H. B. ROBINSON STEAM ELECTRIC PLANT, UNIT NO. 2
DOCKET NO. 50-261/RENEWED LICENSE NO. DPR-23

H. B. ROBINSON STEAM ELECTRIC PLANT, UNIT NO. 2 - REQUEST FOR ADDITIONAL INFORMATION REGARDING APPLICATION TO REVISE TECHNICAL SPECIFICATION SURVEILLANCE REQUIREMENT FREQUENCIES TO SUPPORT 24-MONTH FUEL CYCLES

**RESPONSE TO NRC REQUEST FOR ADDITIONAL INFORMATION REGARDING
TECHNICAL SPECIFICATION SURVEILLANCE REQUIREMENT FREQUENCIES TO
SUPPORT 24-MONTH FUEL CYCLES (RAI EICB-1 THROUGH EICB-19)**

Figure 7: Typical Voltages vs. Minimum Frequency Curves 60 Hertz KF Underfrequency Relay

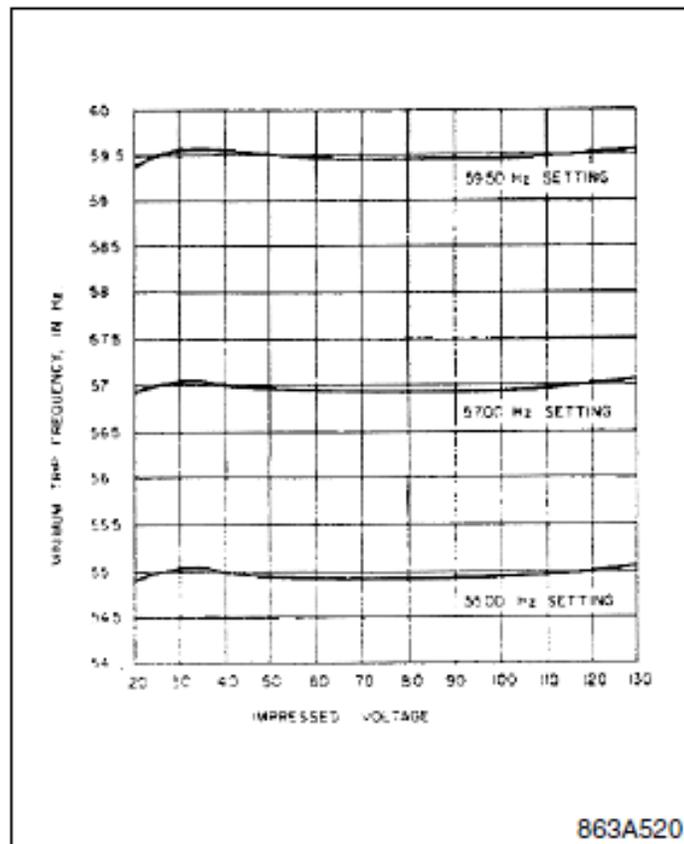
SR 3.3.1.10 Item 12 - RCP [reactor coolant pump] Underfrequency

The licensee states that there were two failures of relay 811/1 after replacement and one failure of relay 811/2 after it was replaced in 2007. Please explain if failure means exceeded the "as-found tolerance" per the licensee acceptance criteria or something else. If some other acceptance criteria is used then please describe and justify the use of the alternate acceptance criteria. In addition, please describe what steps are taken by plant operating procedures to ensure that the relay failures are adequately evaluated and necessary steps are taken to ensure that the relays continue to operate in an acceptable manner without jeopardizing future safe operation of these relays.

The RCP Underfrequency (UF) relays are Westinghouse type KF underfrequency relays. The calibration of these relays is based on Westinghouse Installation, Operation, and Maintenance Instructions I.L. 41-503F, effective May 1968. The voltage versus frequency setpoint response is relatively flat between 120VAC and 40VAC as shown below:

The vendor maintenance instructions include verification that the frequency trip setpoint is between 0.06Hz and 0.08Hz above the desired trip frequency when the applied voltage is reduced from 120VAC to 40VAC. This verification of frequency trip point over varying voltages (120VAC and 40VAC) is referred to in the discussion below as consistency of trip setpoint. RNP Calibration Procedure PIC-806, Westinghouse Type KF Underfrequency Relay, provides a desired trip setpoint of 58.20Hz for 120VAC applied voltage, with a tolerance of 58.00Hz to 58.40Hz. At the 40VAC applied voltage, the desired trip setpoint is 0.07Hz greater than the 120VAC frequency setpoint, and a tolerance of 0.060Hz to 0.080Hz above the 120VAC frequency setpoint.

RNP Technical Specifications Table 3.3.1-1, Item 12, provides a Nominal Trip Setpoint of 58.2Hz, and an Allowable Value of greater than or equal to 57.84Hz. The Allowable Value is applied for the evaluation of calibration as-found data to determine whether the instrument drift exceeded acceptable limits.

For each of these events, the relay was found outside the expected tolerance for consistency over the range of applied voltage. For Relay 811/1 in 2007, the event is conservatively treated as a failure to meet acceptable limits even though the as found data was within the Allowable Value, because the relay could not be adjusted within tolerance. The remaining events found the relay within the Allowable Value and therefore the instrument drift was within acceptable limits.
